CITY OF ALBUQUERQUE

Re: Blue Linx Warehouse Adaptive Re-use Project (Resubmittal)
1820 Bellamah Ave., NW
Traffic Circulation Layout
Engineer's/Architect's Stamp dated 1-15-16 (J13-D101)

Based upon the information provided in your submittal received 1-26-16, the above referenced plan cannot be approved for Building Permit until the following comments are addressed:

PROPOSED SITE PLAN

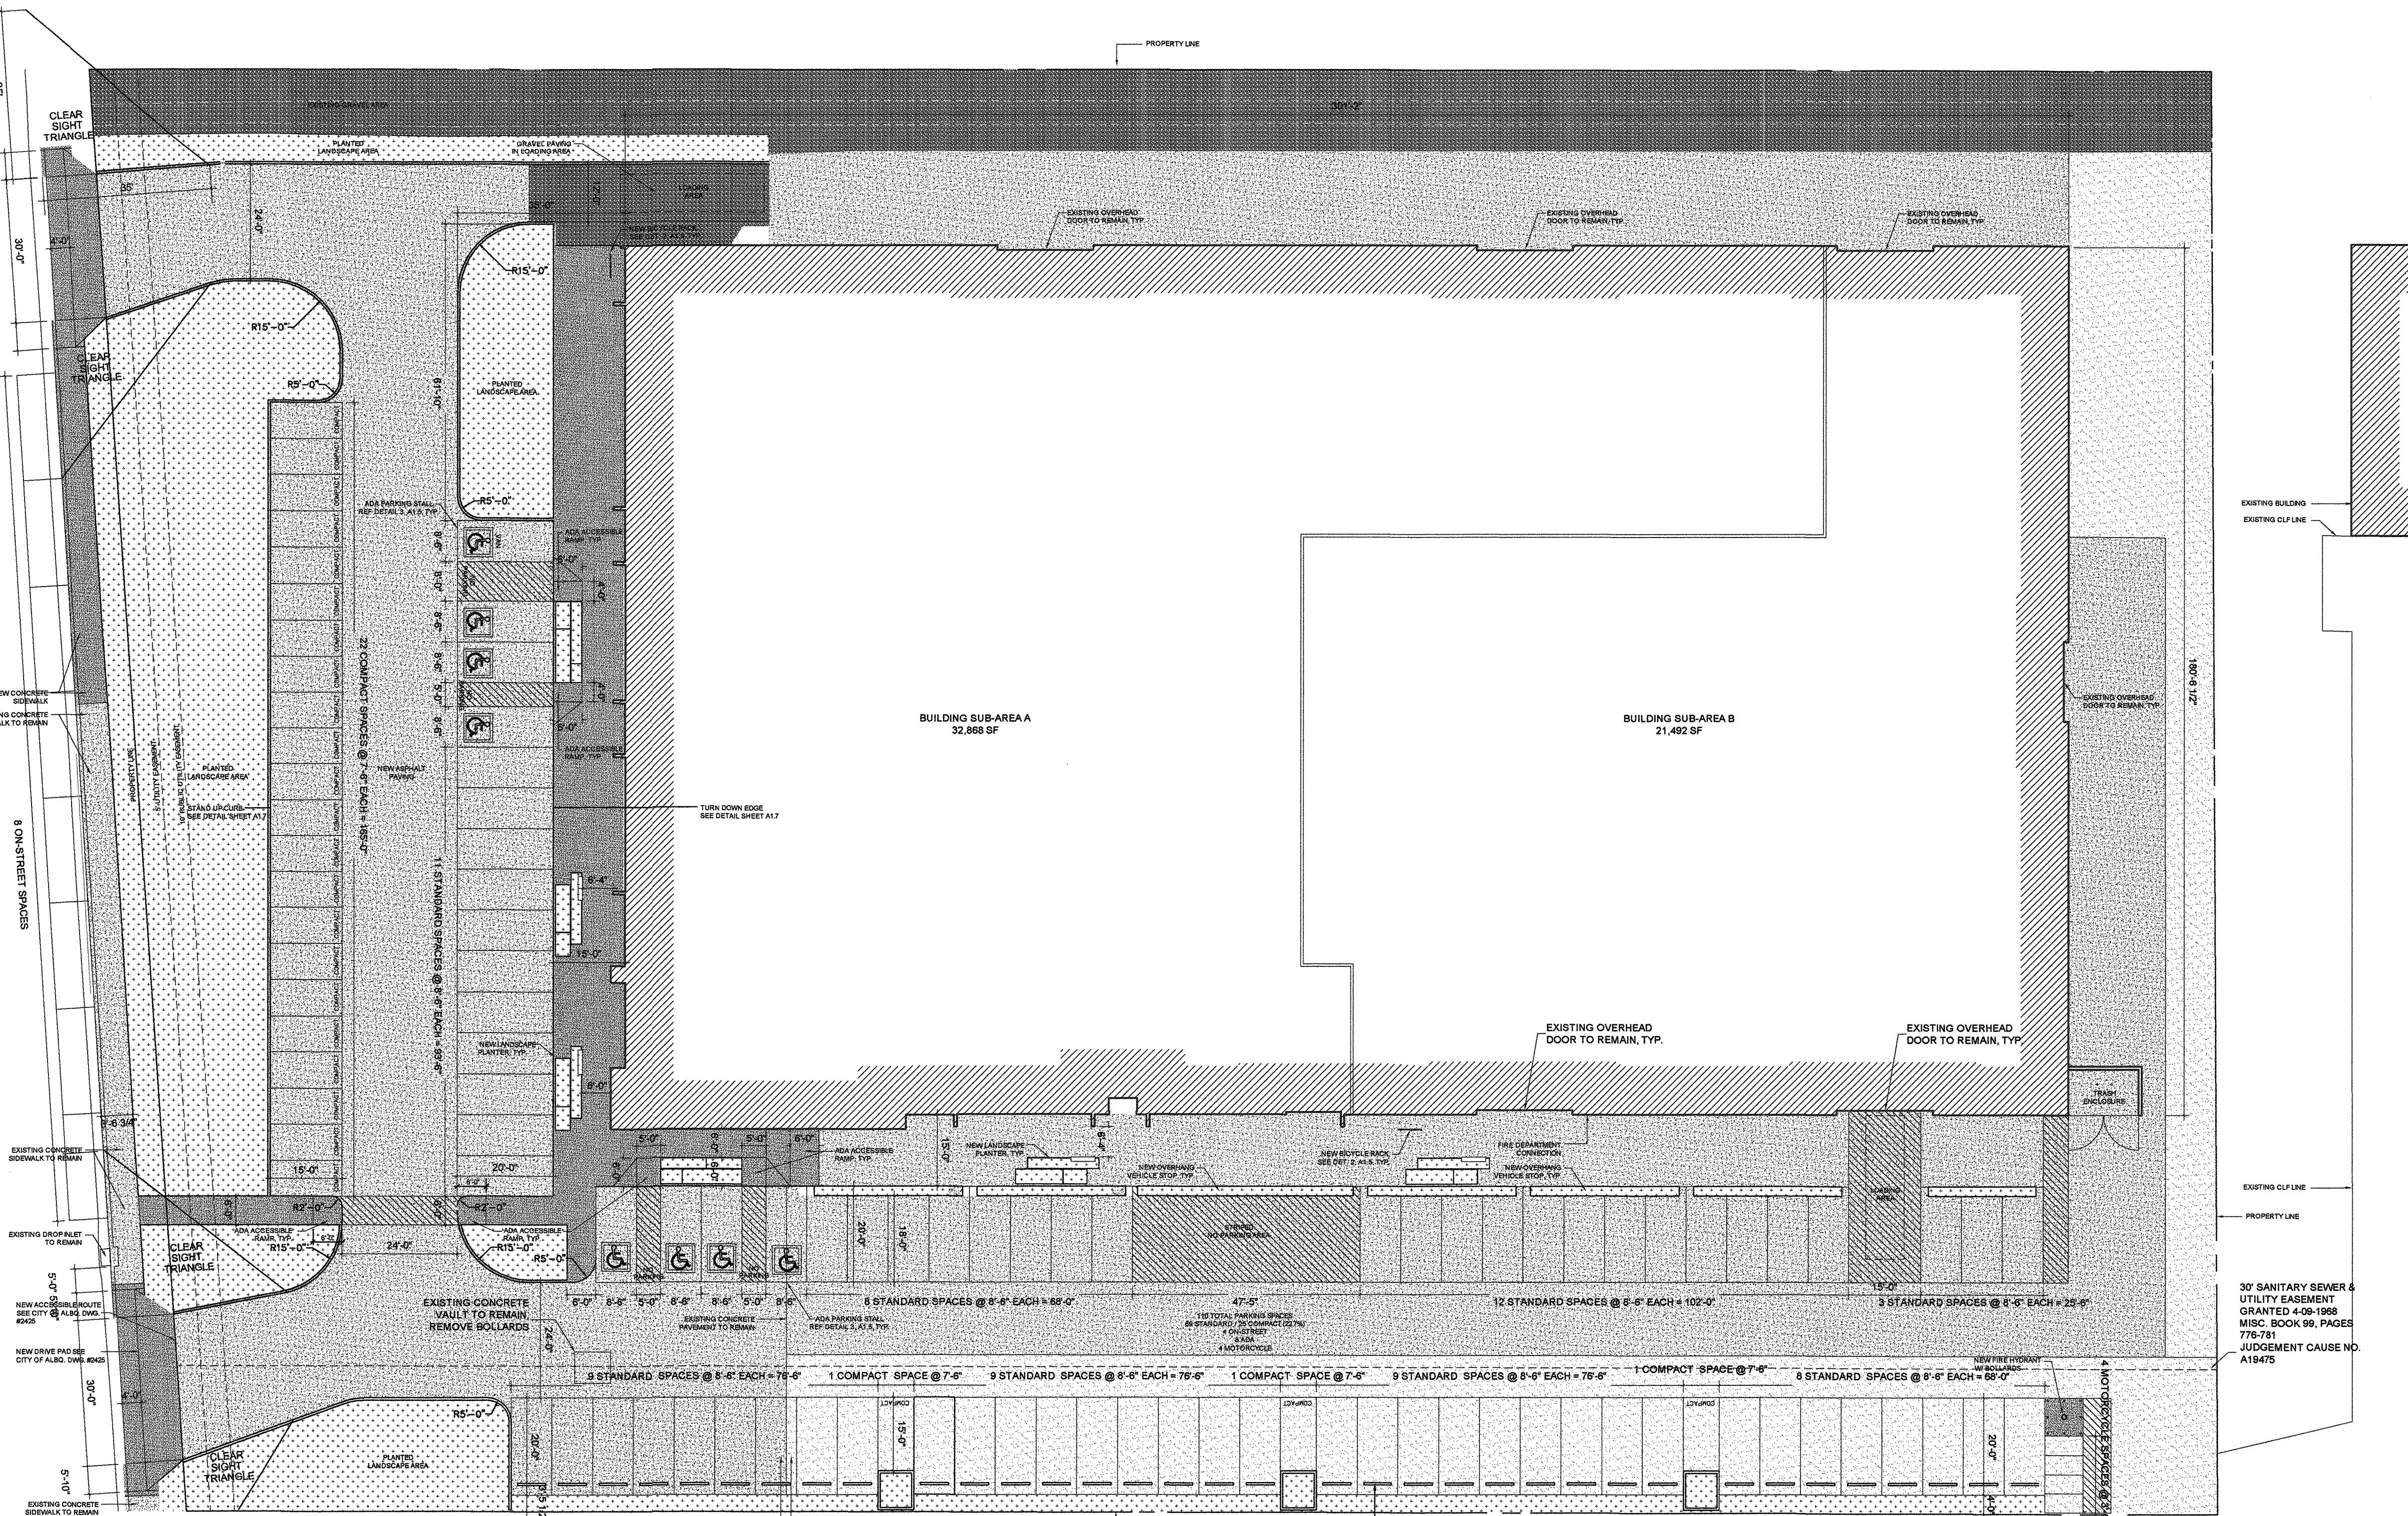
1. Compact parking spaces must be a minimal of 8 ft. in width by 15 ft. in length per COA Compressive Code. In review of the submitted drawing, all compact spaces are dimensioned to be 7.5 ft. by 15ft. Please show detail of reconfigured compact space on new submittal.

2. List the number of parking spaces required by the zoning code as well as the proposed number of parking spaces. Please state the parking calculations with revised count for compact spaces.

3. Identify the right of way width, medians, curb cuts, and street widths on 18th and 19th St.
4. Per Fire Marshall, a fire line access isle will be required in front of the AFD connection point on the west side of the building.

5. Please identify and dimension all existing and proposed sidewalks, pedestrian walkways and entrances to existing building. Note that hatch details make review of dimension difficult, if detail is too dark to read underlying dimensions.

6. Please detail and dimension all existing handicap ramps on public right-of-way and drive pads.
7. Please provide a detail of ADA access ramps to building entrances.

8. Per the DPM, a 6 ft. wide ADA accessible pedestrian pathway is required from the public sidewalk to the building entrances. Please clearly show this pathway and provide details. In review of submittal drawing, new ADA accessible route is noted to be located in the drive pad, which is not in compliance to ADA requirements.

9. Provide a min 6" or max 8" high concrete barrier curb or other acceptable barrier between landscaping and parking areas and/or drive aisles. Please call out this detail.

10. Design delivery vehicle route needs to be shown.
11. Service vehicle and/or refuse vehicle maneuvering must be contained on-site; provide a copy of refuse approval.
12. All broken or cracked sidewalk must be replaced with sidewalk and curb & gutter. A build note must be provided referring to the appropriate City Standard drawing.
13. Please include two copies of the traffic circulation layout at the next submittal.
